C35-75

Letter - C35

FIGURE DD-1
EIMRICH 2 1 0

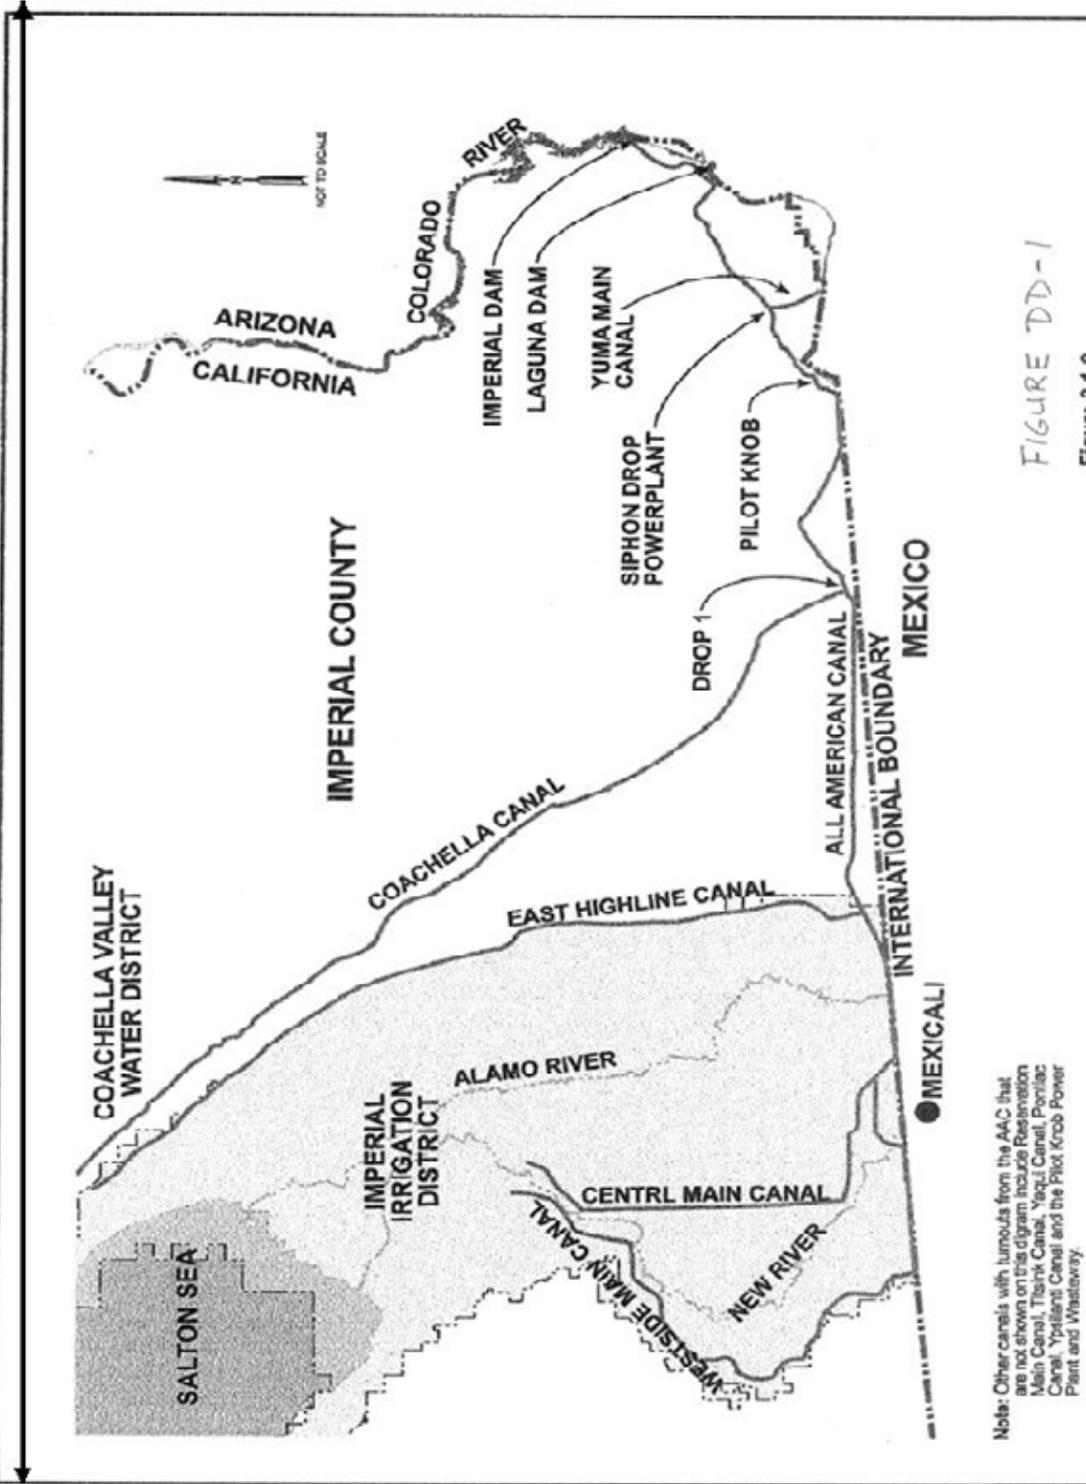
Connecting the AAC to the SDCWA system via pipeline between the western end of the AAC and the San Vicente Reservoir IS a via alternative. The sentence under the discussion section stating "This alternative may also require a canal parallel to the AAC, from the eastern portion of the extension, east to Imperial Dam because the AAC may not have sufficient capacity to carry transfer water" is questionable. Figure DD-1 (3.1-9) Project Site Features, shows the canal arrangement and Table DD-3 (Table 3.1-3): Annual Average Gross Diversion from Colorado River into AAC (1987-1998) - the water budget. IID/CVWD's take at Imperial Dam has historically been 3.43 MAFY (3.100 MAFY for IID and 0.330 MAFY for CVWD) and at Pilot Knob measured average is 3.292 MAFY after a conveyance loss of 140 KAFY. Under the proposed Project, Imperial Dam take by IID/CVWD is planned to be 3.066 MAFY (2.610 MAFY IID and 0.456 MAFY CVWD - see Table DD-4 (Table 2-1): Annual Colorado River Water Budgets with Implementation of QSA. Flow at Pilot Knob under full Project conditions, after allowing for a conveyance loss of 72 KAFY, is projected to be 2.994 MAFY. Note that conveyance loss has been reduced by 68 KAFY from the historical number to reflect the planned lining of a 23 mile section of the

Response to Comment C35-85(continued)

As described in Appendix D of the Draft EIR/EIS, impacts because of the reduction in flow are considered to be fully mitigated with implementation of biological conservation measures described in Section 3.2 of the Draft EIR/EIS. SDCWA has evaluated several optional alignments to connect the All American Canal facilities within the IID water service area and the SDCWA system at San Vicente Reservoir. The routes generally follow existing roadways and powerline rights-of-way and easements between these two points, primarily Interstate 8. It is anticipated that operation of the new pipeline would have a minimal effect on the diversion and desilting capacity at Imperial Dam. However, the All American Canal capacity below Drop 3 may have to be increased to accommodate year-round transportation of water. Additional storage reservoirs for daily operations may be required in the IID water service area. Storage may also be required at San Vicente Reservoir. The new pipeline would consist of two to three parallel, 5- to 6-foot diameter pipes, mostly above ground because of seismic and soils conditions. The construction corridor would be approximately 150 to 200 feet wide and would range in length from 90 to 150 miles (depending on the alignment selected). Total pumping requirements would be approximately 0.2 to 0.3 million horsepower.

Implementation of this alternative could result in a number of substantial and possibly unavoidable significant impacts to water resources, biological resources, geology, soils and mineral, agricultural resources, air quality, cultural resources, noise, aesthetics, and hazards and hazardous materials. (These impacts are described in greater detail in the Implementation of the Draft Colorado River Quantification Settlement Agreement Program EIR, January 2002, Chapter 5.) Therefore, this alternative does not potentially reduce impacts compared to the Proposed Project and does not warrant full evaluation in the EIR/EIS. Additionally, because this alternative would not reduce the requirements for mitigation at the Salton Sea and would involve extensive additional construction, it would be significantly more expensive than the Proposed Project.
